Response to Canal + River Trust comments - 09th July 2026

We have received the following comments from Canal + River Trust Spatial Planning Team in respects of planning application 2026/90387 at Upper Mills, Canal Side, Slaithwaite, Huddersfield, HD7 5HA.

Photo 1 - Permeable floor surface through-out.

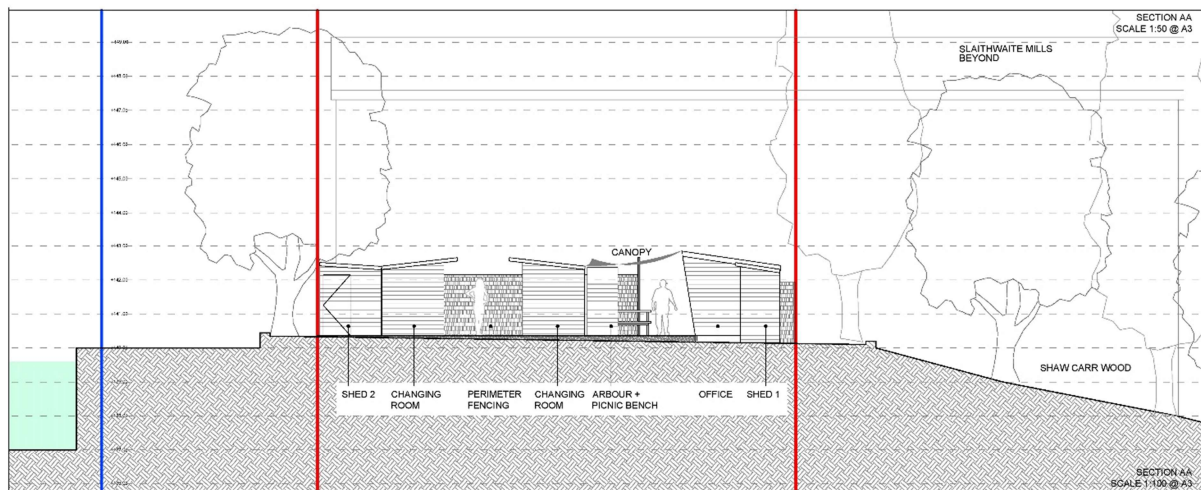
“The application form states that surface water on site it to be managed through the use of a Sustainable Drainage System (SuDs). No detail upon this has been provided.”

The application form identifies both SuDS and the Mains sewer as part of the site's drainage strategy.

The entire site floor area will be finished with permeable, free-draining surfacing (pea gravel and woodchip), allowing rainfall to infiltrate naturally into the ground. The only impermeable elements are the small timber shed-style roofs, which together occupy approximately 19% of the 277m² site area. Rainwater from these roofs will discharge directly onto the surrounding permeable ground rather than into a piped surface water system.

Section AA

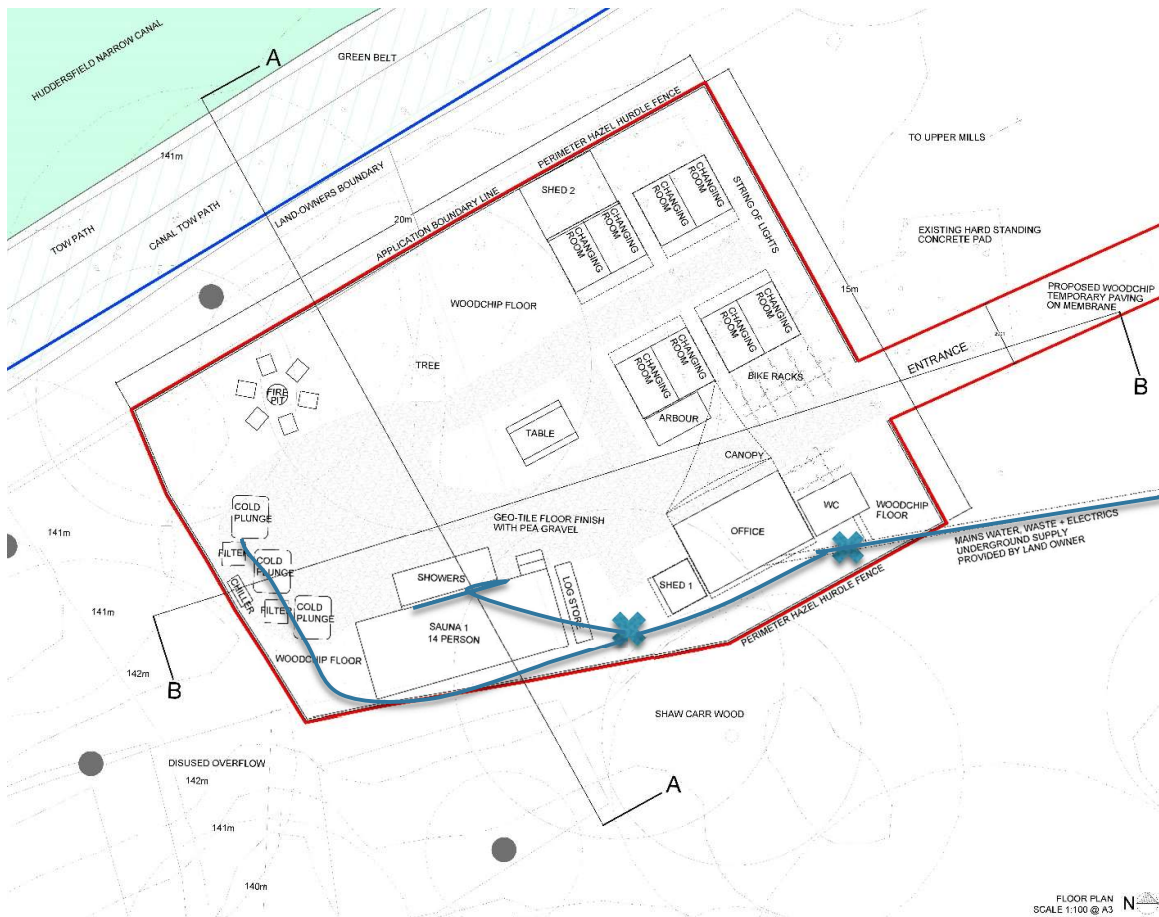
"We request that details of the management of surface water should be provided in order to ensure that it will be appropriately managed and will not result in unmanaged water discharge to the canal or watercourses that interact with the canal."

Surface water will be managed to ensure there is no unmanaged discharge to the canal or to watercourses that interact with it.

The site is surfaced with permeable, free-draining materials, allowing rainfall to infiltrate into the ground. The site's topography is generally level, with a gradual fall towards the former mill dam and the River, rather than towards the canal. It is understood that, prior to the land becoming disused, this area formed part of the historic mill dam.

Section A-A illustrates the approximate relationship in levels between the canal on the left of the image, the application site and the River on the right, demonstrating that surface water does not naturally drain towards the canal.
